**PRELIMINARY DRAINAGE REPORT**

**CIRCLE K at  
HIGHWAY 24 & MERIDIAN ROAD**

**PCD File # VR-22-03**

SHEET 1 OF 2  
DR01

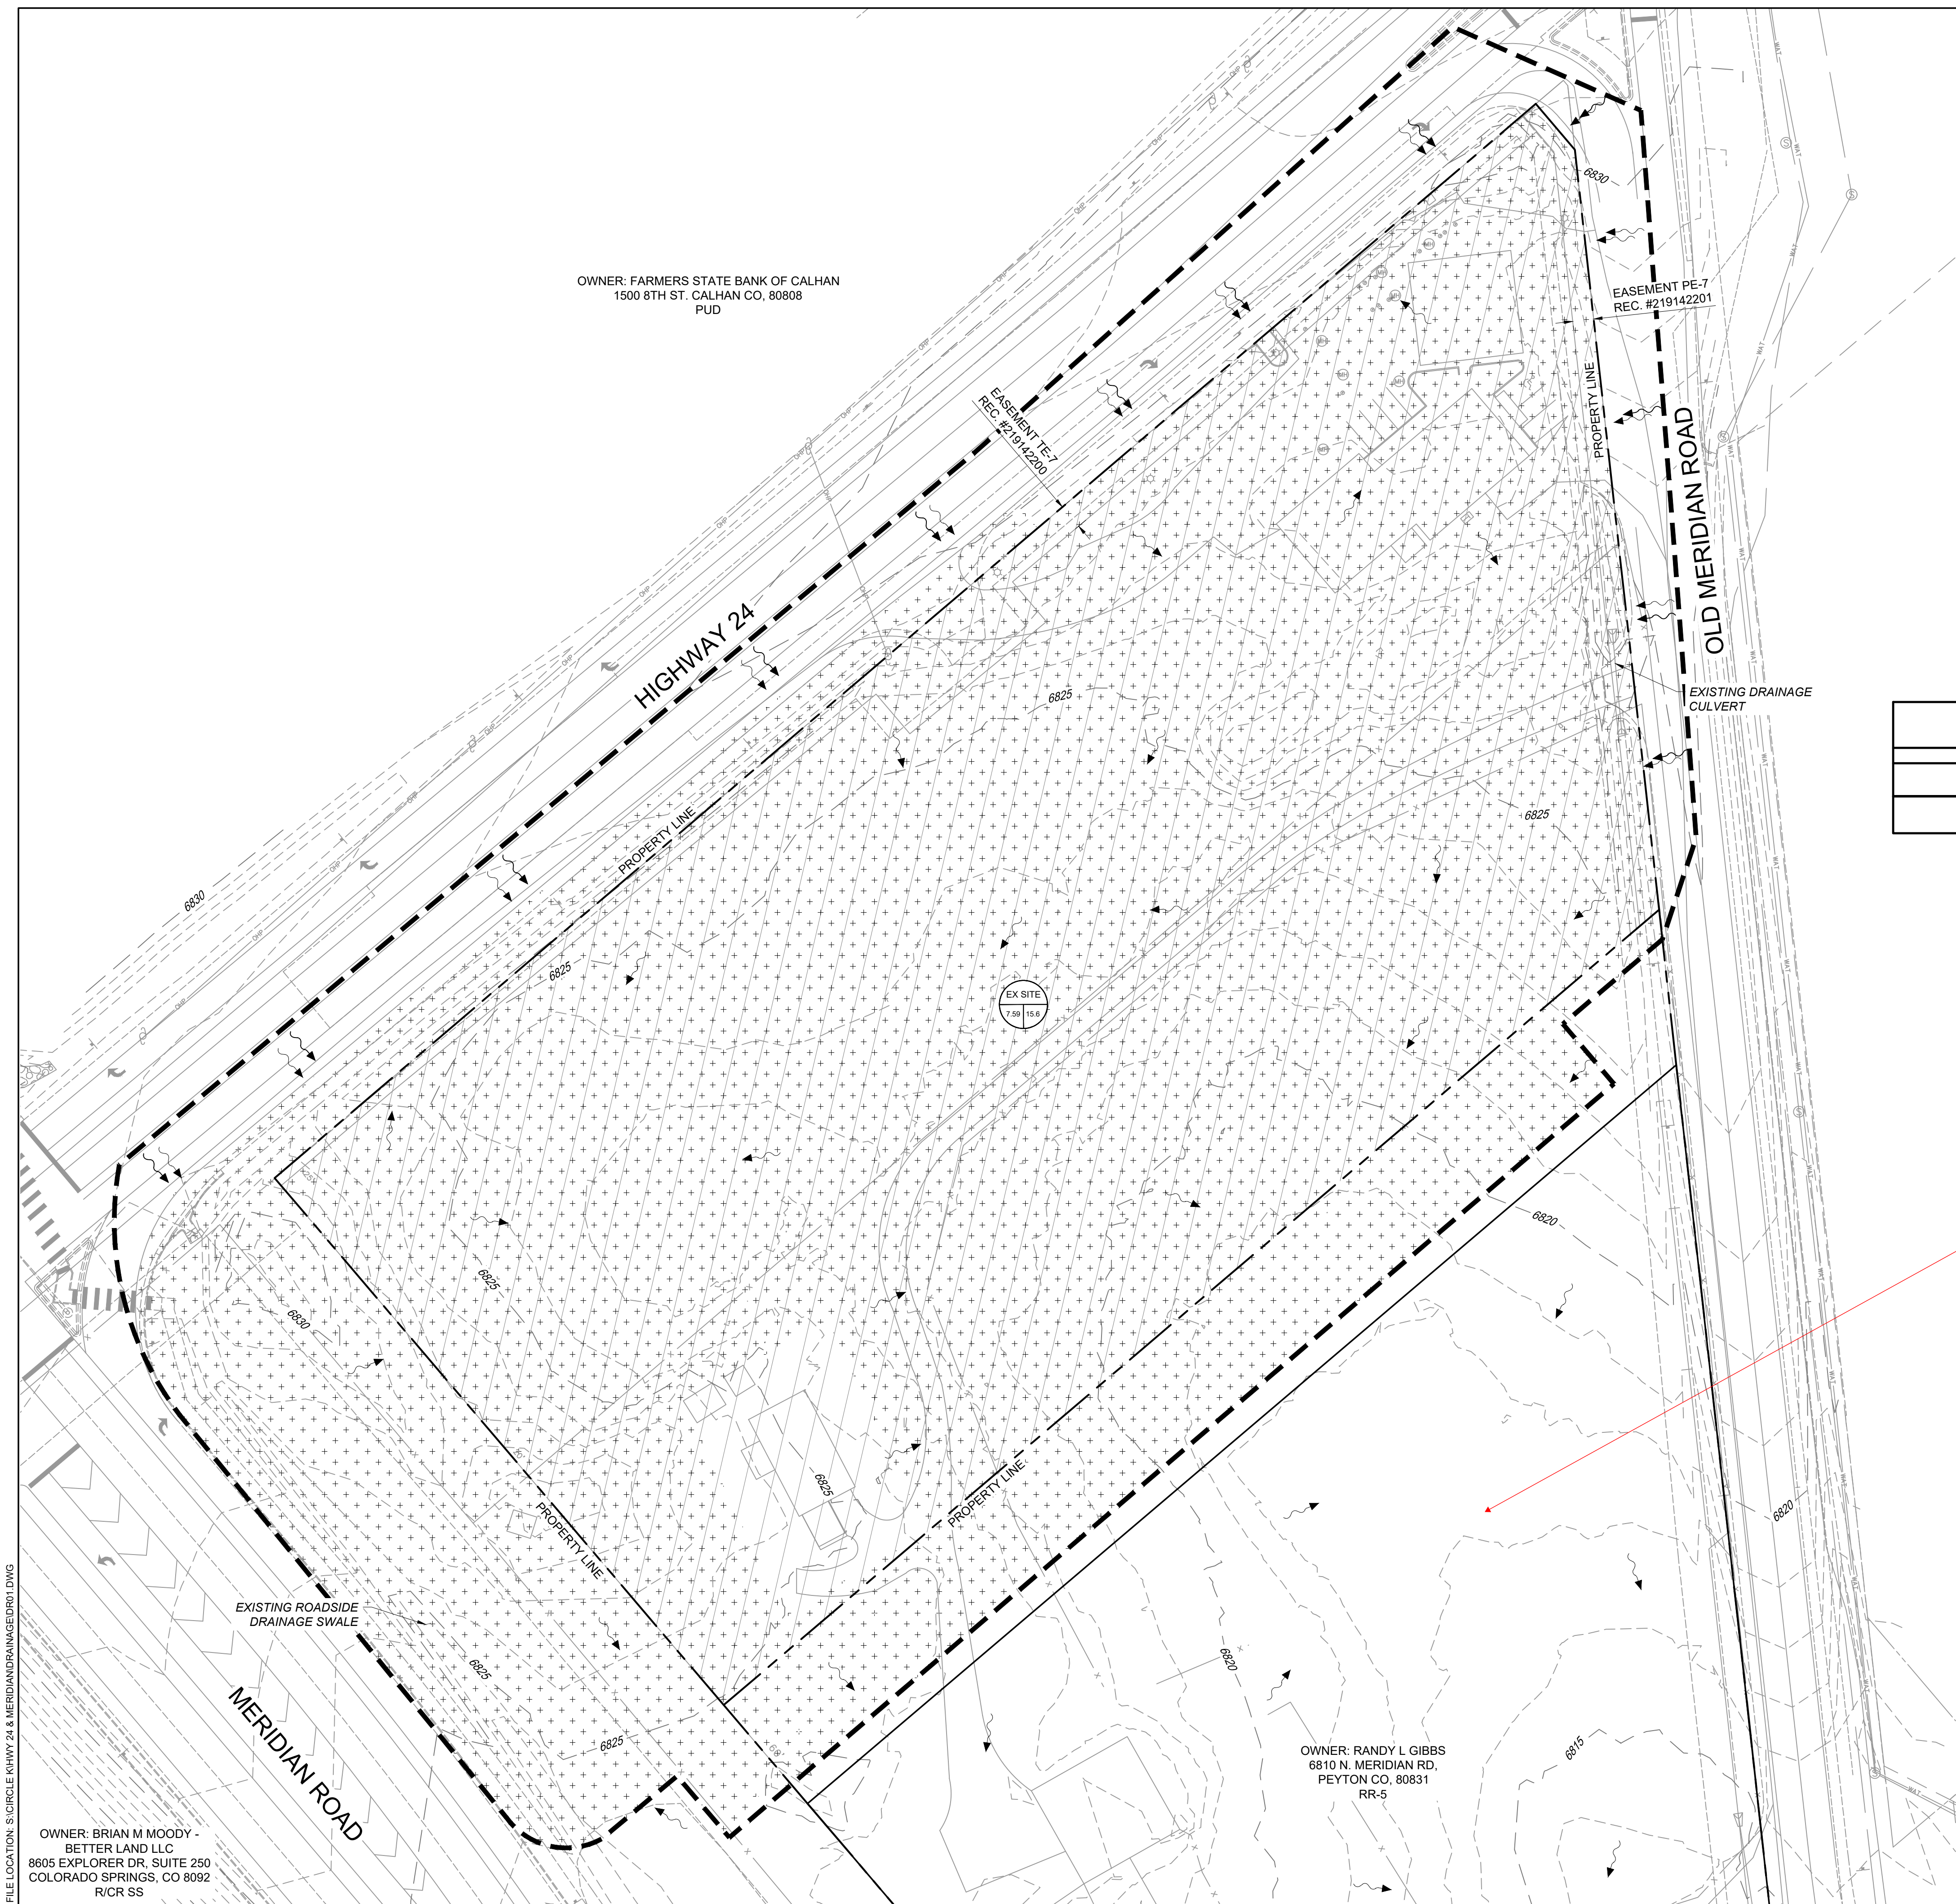
Show the entire Lot #2 an address current flows  
Show existing street drains on New Meridian

# PROPOSED DRAINAGE MAP

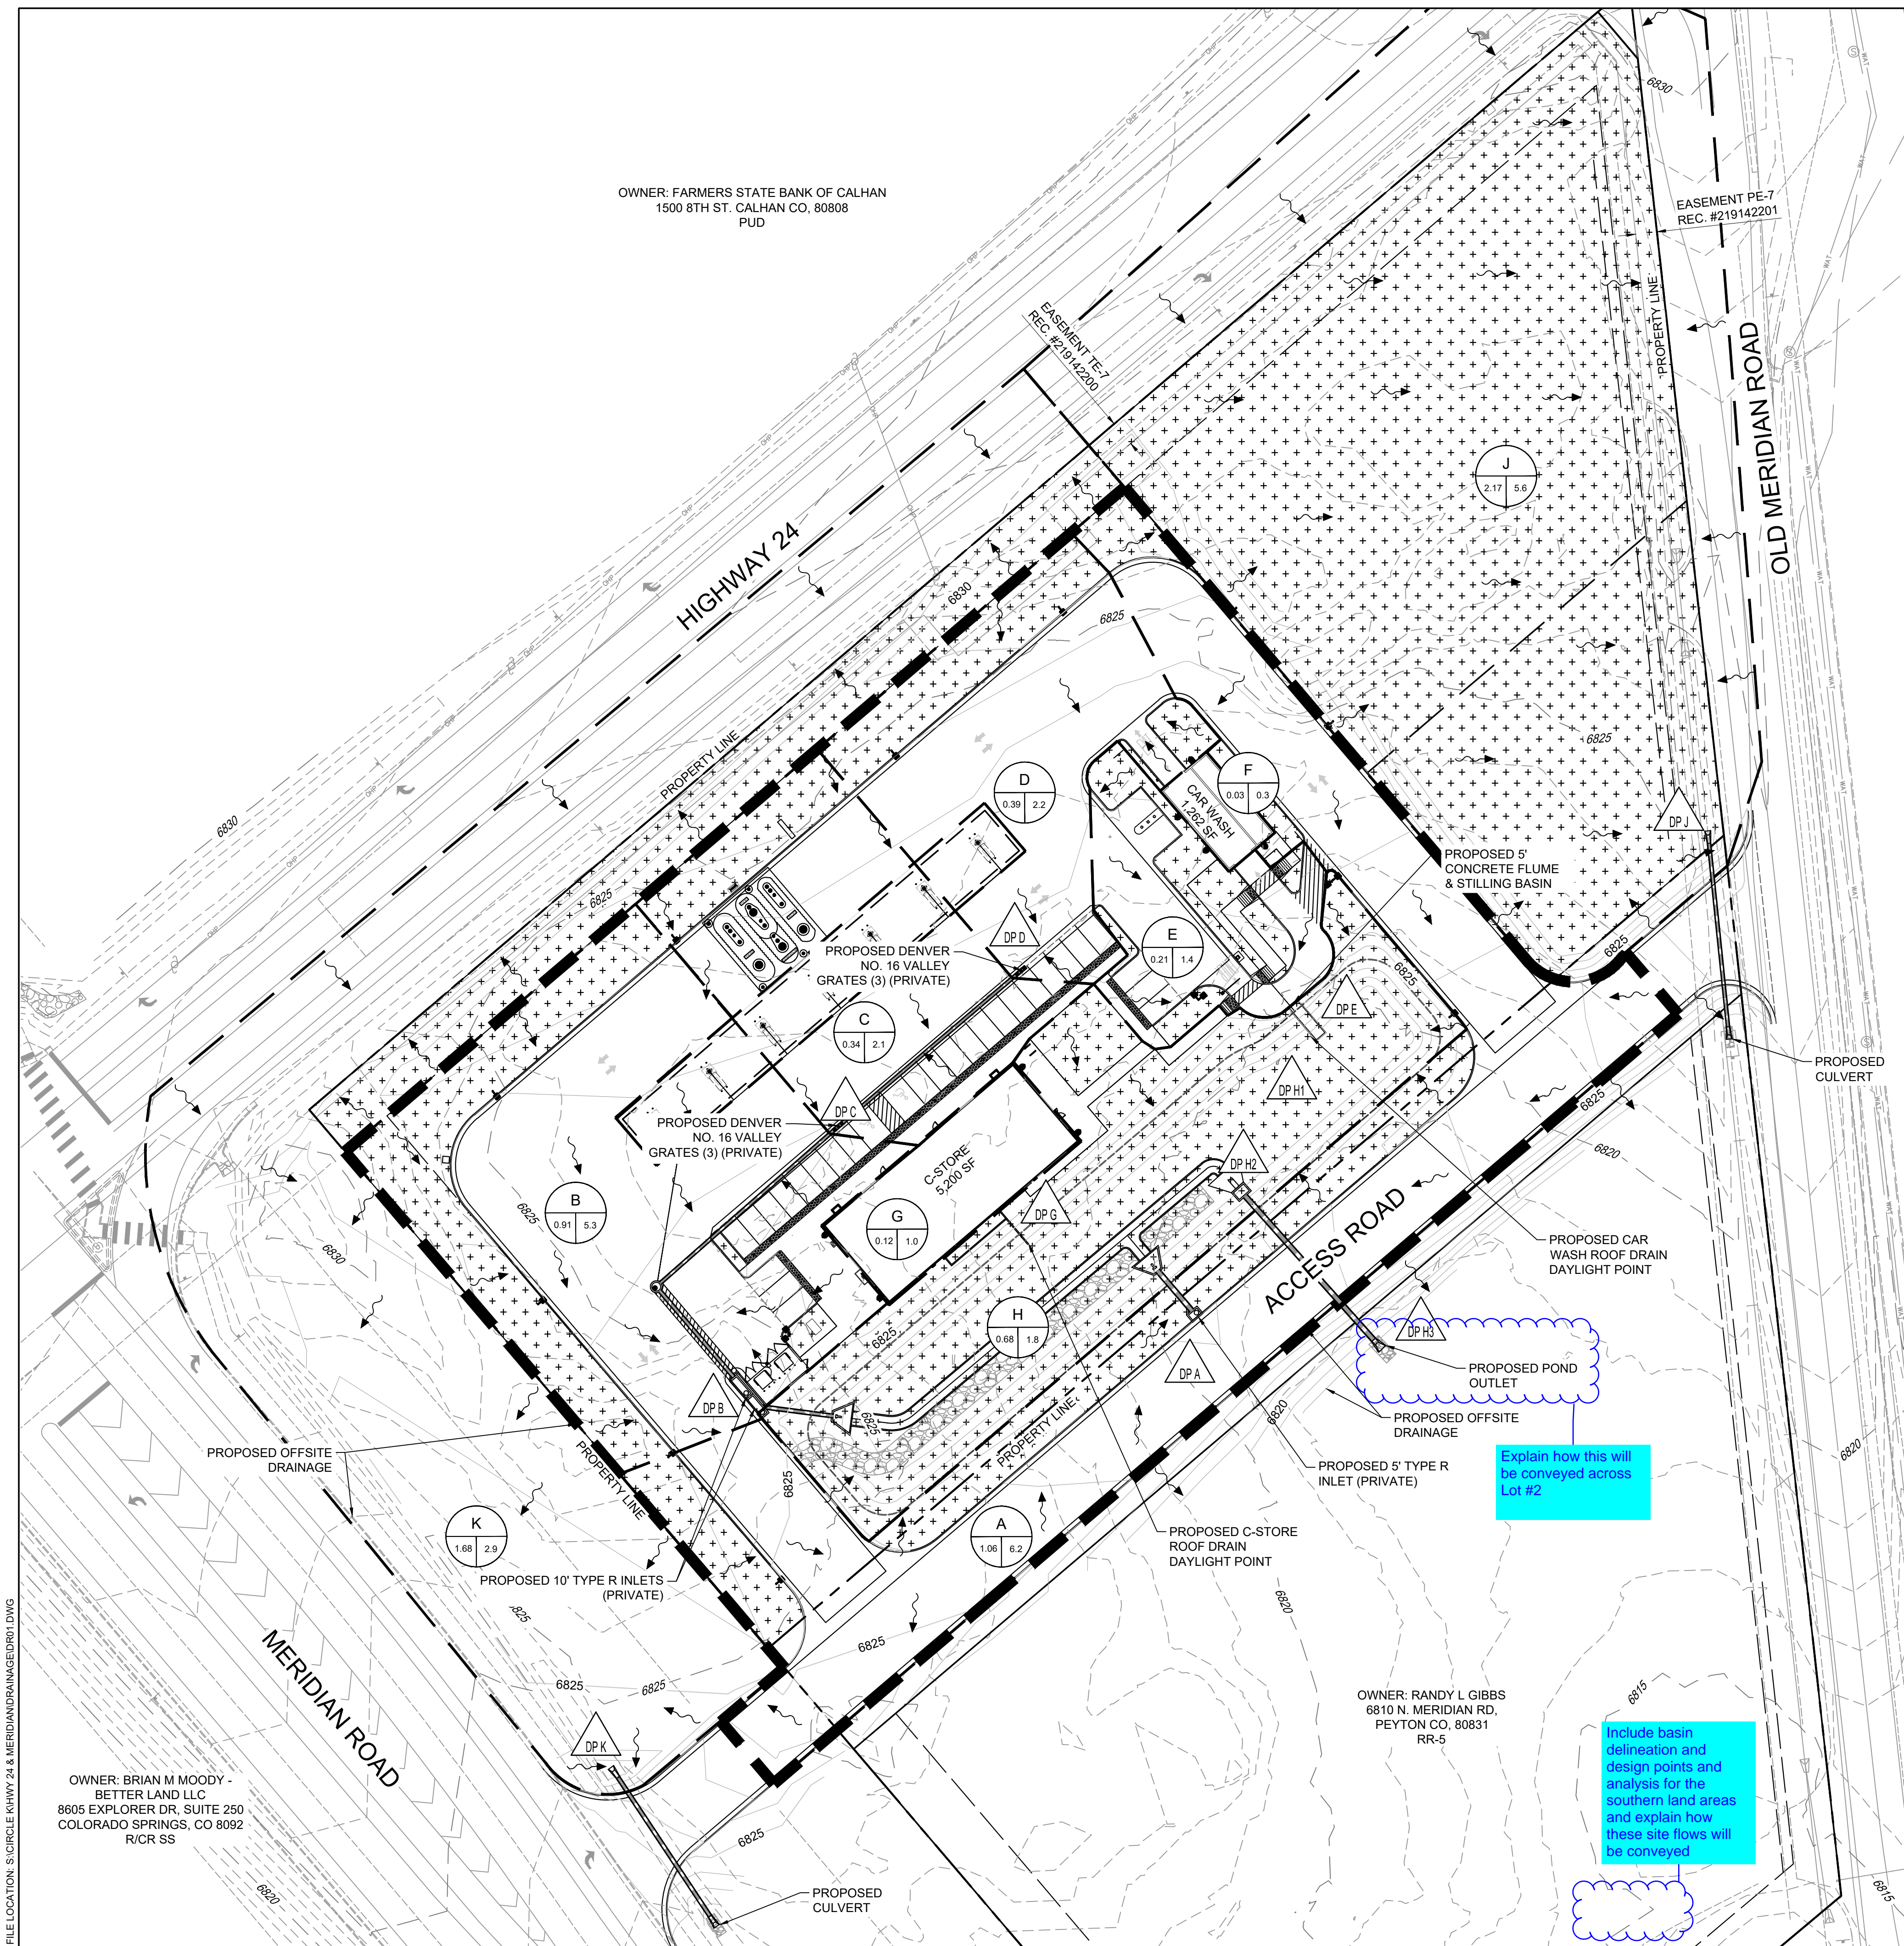
Proposed conditions drainage map need to comprise the entire subdivision area and Lot #2

Explain how this will be conveyed across Lot #2

Include basin delineation and design points and analysis for the southern land areas and explain how these site flows will be conveyed
